SERVICE BULLETIN

Service Bulletin No.: DA20-79-03 Rev 1

Title: Oil Dipstick, Thermal Insulator

Figure 01 - Oil Dipstick Installation

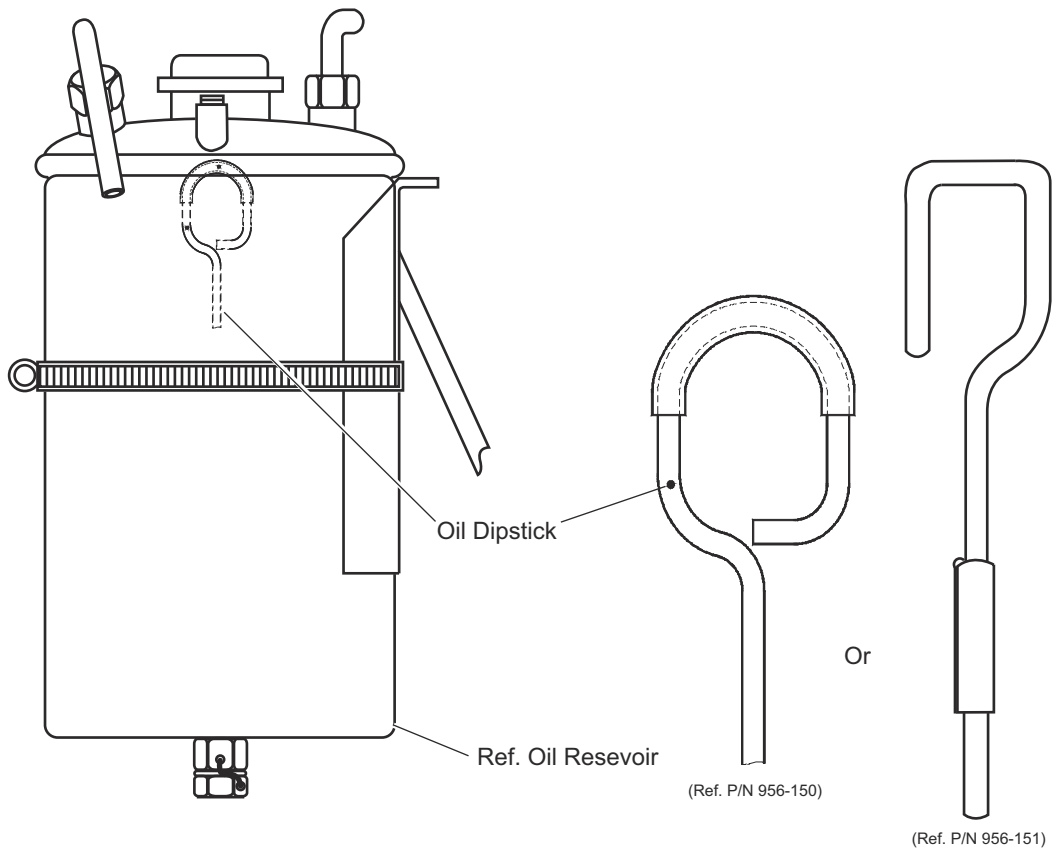
- 10.1 Remove the upper cowling from the aircraft.
- 10.2 Remove the oil reservoir cap.
- 10.3 Remove the oil dipstick.
- 10.4 Use a bench vise to open bend, lubricate handle with engine oil and slide Fluran tubing on to distick as shown in Figure 1.
- 10.5 Close bend to its original shape.
- 10.6 Ensure Fluran tube is located evenly on the top of the handle.
- 10.7 Make a log book entry that this Service Bulletin has been incorporated.
